NINE MILE POINT NUCLEAR STATION UNIT NO. 1

TECHNICAL EVALUATION REPORT

(BACK-END)

NINE MILE POINT UNIT 1
TECHNICAL EVALUATION REPORT ON THE
INDIVIDUAL PLANT EXAMINATION
BACK-END ANALYSIS

Figure 4.7-4
Comparison of the Definition of 'Early' Radionuclide Release

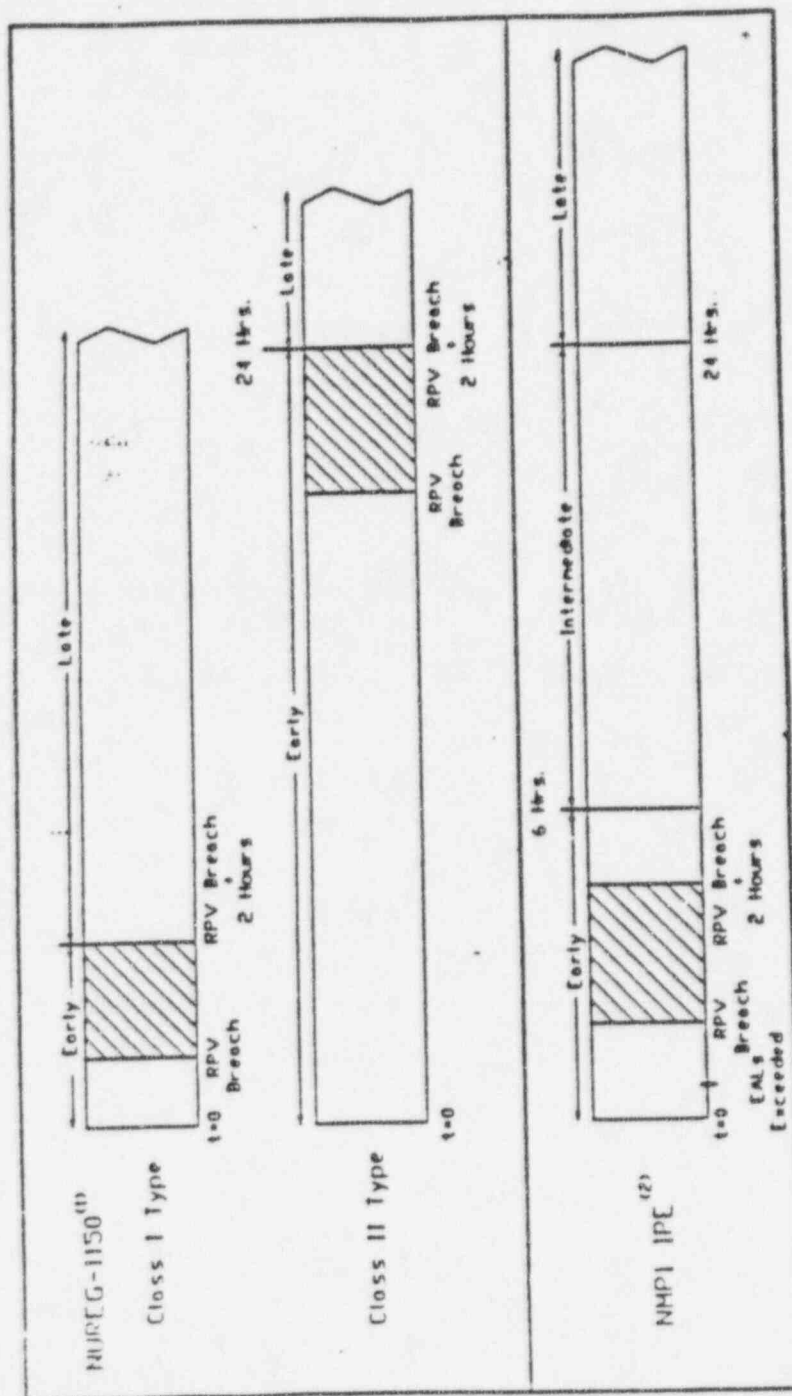
Usually, the release time is defined based on the occurrence of vessel breach. For example, NUREG-1150 defined early containment failures for BWRs as those occurring before or within 2 hours of vessel breach. Figure 2, reproduced from the submittal, compares the definition of "early" radionuclide release used in the IPE with its definition in the NUREG-1150 study. Any comparisons of NMP1 results with those of other IPEs and NUREG-1150 have to be made accordingly.

Figure 4.6-17
Summary of Initial Containment Failure Modes:
Contributors to Total Release

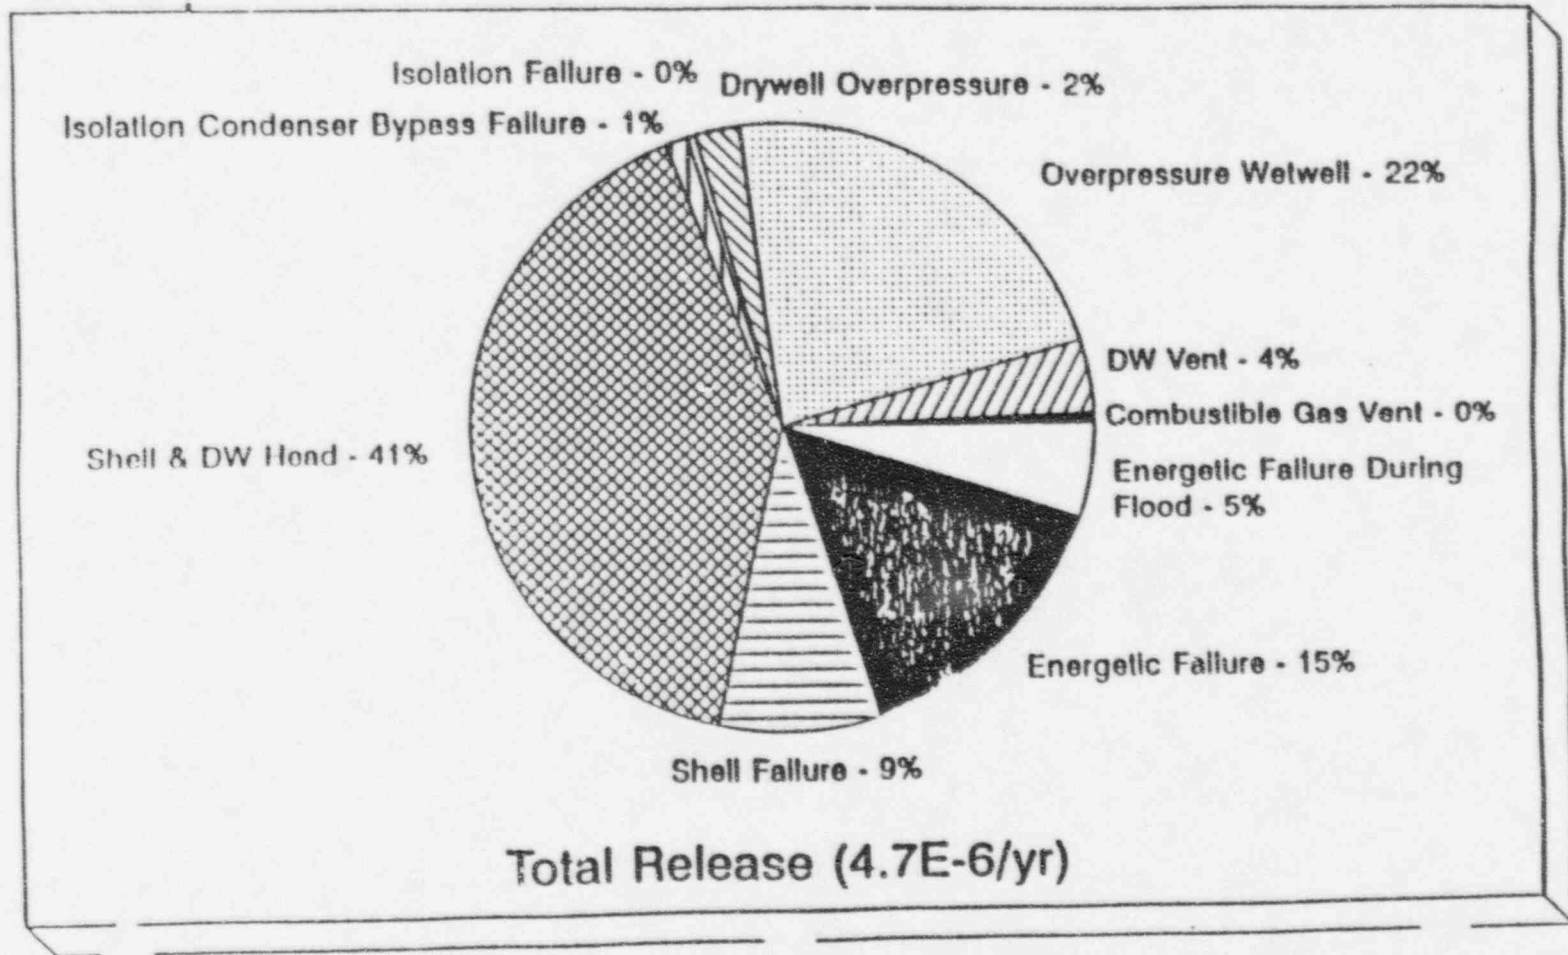
It appears that the principal mode of containment failure would be shell failure coupled with subsequent drywell head failure (41 percent of the total release) followed by wetwell overpressure failure (22 percent). Energetic failure modes of containment due to rapid overpressurization at RPV failure, steam explosion, direct containment heating (DCH) and hydrogen detonation contributed 15 percent to the total release. The probability of containment isolation failure was shown to be negligible due to a highly reliable containment isolation system and also a normally inerted containment. Controlled venting of the drywell accounted for 4 percent of the total release.

Figure 4.6-17 of the submittal shows that the principal mode of containment failure would be shell failure, coupled with a subsequent drywell head failure (41 percent of total release), followed by wetwell overpressure failure (22 percent). Energetic failure modes due to rapid overpressurization at RPV failure, steam explosion, direct containment heating (DCH), and hydrogen detonation would contribute 15 percent to the total release. Containment isolation failure probability would be negligible: the containment isolation system was shown to be highly reliable and containment normally inerted. Controlled venting of the drywell would account for 4 percent of the total release.

Figure 4.6-18
Summary of Initial Containment Failure Modes:
Contributors to "Large" (Early/High) Release

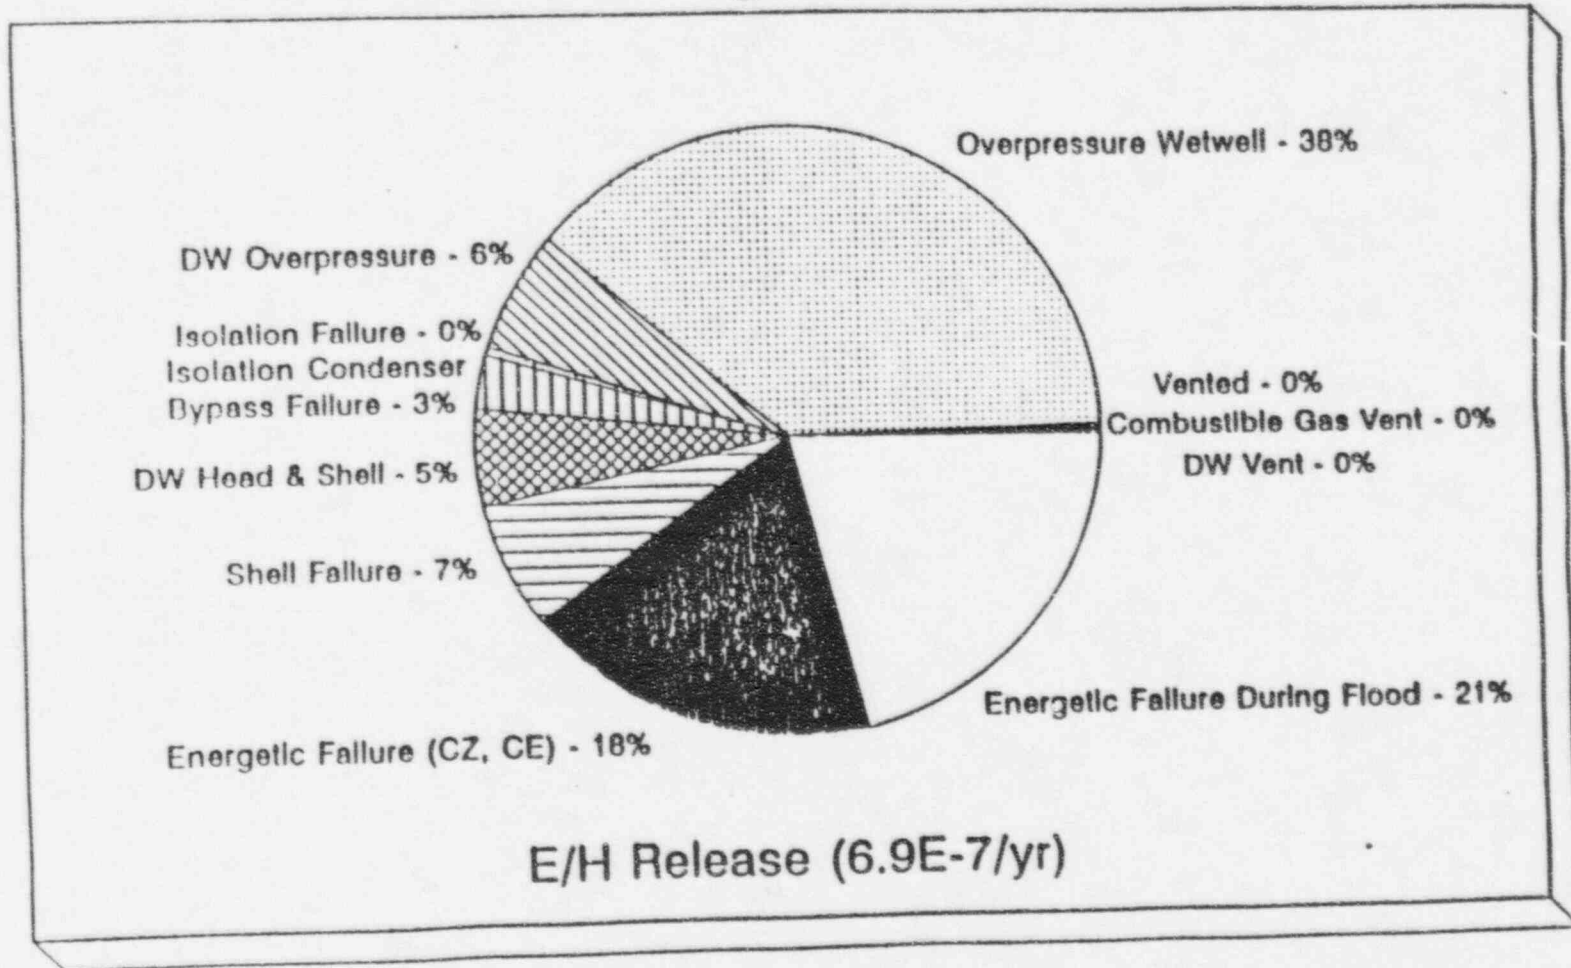
As an indicator of plant response to accident initiators, the frequency with which a "large" radionuclide release would occur was used as an indicator of containment performance and risk to the public in the back-end analysis, just as it was used in the front-end analysis. The "large" release category was defined based on the magnitude and timing of the radionuclide releases. The category includes those accident sequences that would result in "high" releases (greater than 10-percent CsI fission products) and "early," i.e., in less than 6 hours following accident initiation. According to the IPE, this definition is consistent with the NRC staff definition of a "large" release in SECY-90-405, but is dissimilar to the NUREG-1150 definition. The frequency with which a large radionuclide release would occur was estimated to be $6.9\text{E-}7$ per year. This represents only 13 percent of the total release frequency. The dominant initiating event contributors were ATWS (40 percent), station blackout (28 percent), medium LOCA (16 percent), small LOCA (5 percent), large LOCA (4 percent) and interfacing system LOCA (4 percent). It appears that the principal mode of containment failure for a "large" release would be wetwell overpressure failure (38 percent of a large release), primarily found to occur in ATWS sequences. Energetic failures during containment flooding (21 percent) and non-flooded containment energetic failures (18 percent) were the other dominant containment failure modes leading to a large release.

Figures 3 and 4, both reproduced from the submittal, show containment failure modes as contributors to total release and to "large" (early/high) release, respectively.
